Planning Application 25/00358/FUL - 2A Dick Place EH9 2JN

**OBJECTION from Grange Association**

**17 February 2025**

Roof material

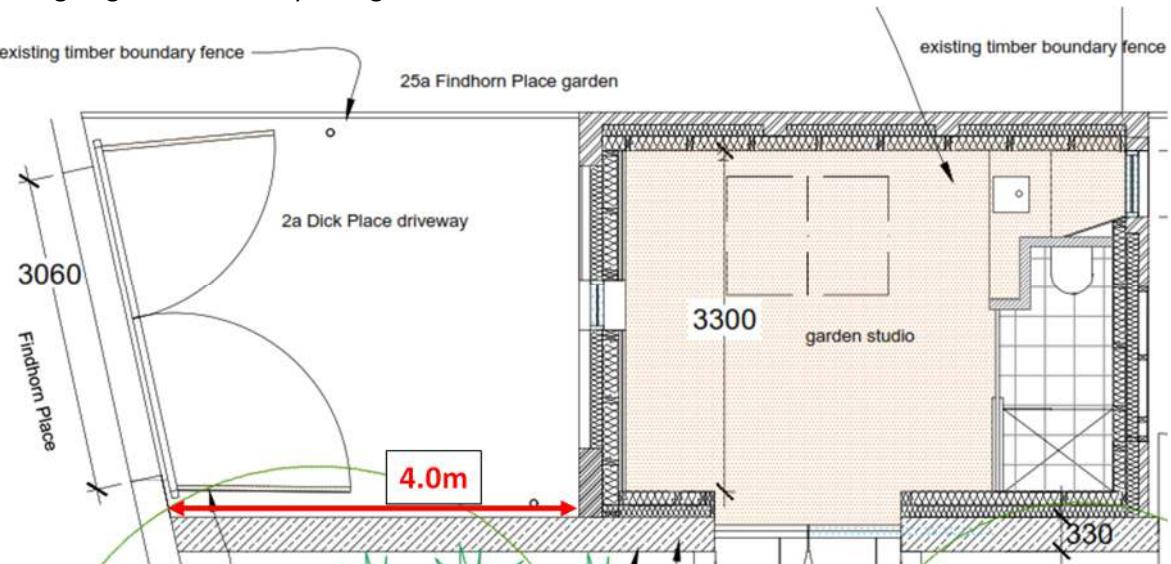
The elevation drawings submitted with the application specify the roof for the new art studio to be “*sinusoidal grey steel sheet*”. This is likely to have the appearance of corrugated iron and is not compatible with materials traditionally used in the conservation area. It would not enhance the setting of the listed building. The Council’s consultation draft “[Listed Buildings and Conservation Areas \(2024\)](#) (page 25) notes:

We therefore request that the applicant be requested to amend the proposals to include a slate roof for the art studio.
